Access Compliance Report

Public Rights-of-Way

(Curb Ramps)

Intersection ID: 10035003	Main Street: PROVIDENCE_RD	Cross Street: N/A	Location: SE
ADA ID: 1C04BC4D4EEC	Ramp Type: PerpDiag	Initial Pass/Fail: Fail	Overall Compliance: No
		Severity Score: 25

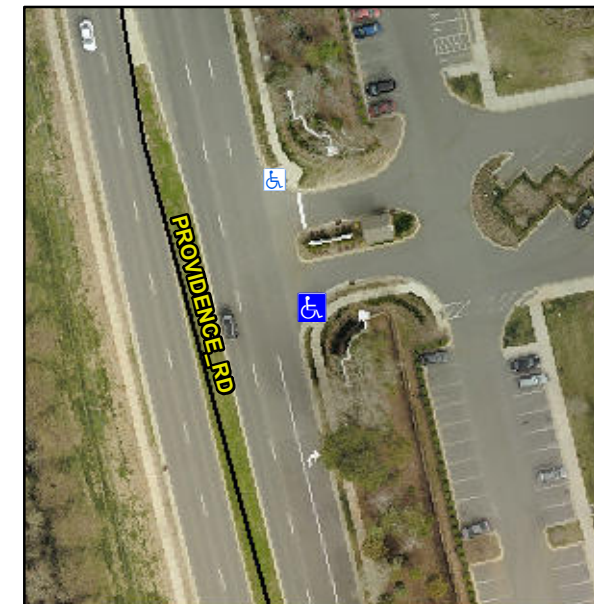
R304.5.3

Compliance	Description	Data	Compliance	Description	Data
N/A	Ramp Length (in)	105.0	Yes	Ramp Slope (%)	7.6
Yes	Ramp Width (in)	48.0	No	Ramp XSlope (%)	10.4
N/A	Flare Type LT	N/A	N/A	Flare Type RT	N/A
N/A	Flare Slope LT (%)	N/A	N/A	Flare Slope RT (%)	N/A
N/A	Flare Traversable LT?	N/A	N/A	Flare Traversable RT?	N/A
N/A	Landing Length (in)	N/A	N/A	DWS Provided?	N/A
N/A	Landing Width (in)	N/A	N/A	DWS Contrast?	N/A
N/A	Landing Slope (%)	N/A	N/A	DWS Length (in)	N/A
N/A	Landing X Slope (%)	N/A	N/A	DWS Full Width?	N/A
N/A	Landing Curb? (Y/N)	N/A	N/A	DWS Offset (in)	N/A
N/A	Shared Landing?	N/A			
N/A	Gutter Ponding?	N/A	N/A	Gutter Slope (%)	N/A
N/A	Gutter Lip Ht (in)	N/A	N/A	Gutter X Slope (%)	N/A
N/A	Painted X Walk1?	No	N/A	Painted X Walk2?	No
	X Walk 1 Direction	To N		X Walk 2 Direction	To W
N/A	X Walk 1 Width (in)	N/A	N/A	X Walk 2 Width (in)	N/A
	X Walk 1 Slope (%)	5.6		X Walk 2 Slope (%)	3.2
	X Walk 1 X Slope (%)	3.2		X Walk 2 X Slope (%)	5.8

Remove & Replace Curb Ramp With Two New Directional Ramps or Equivalent.
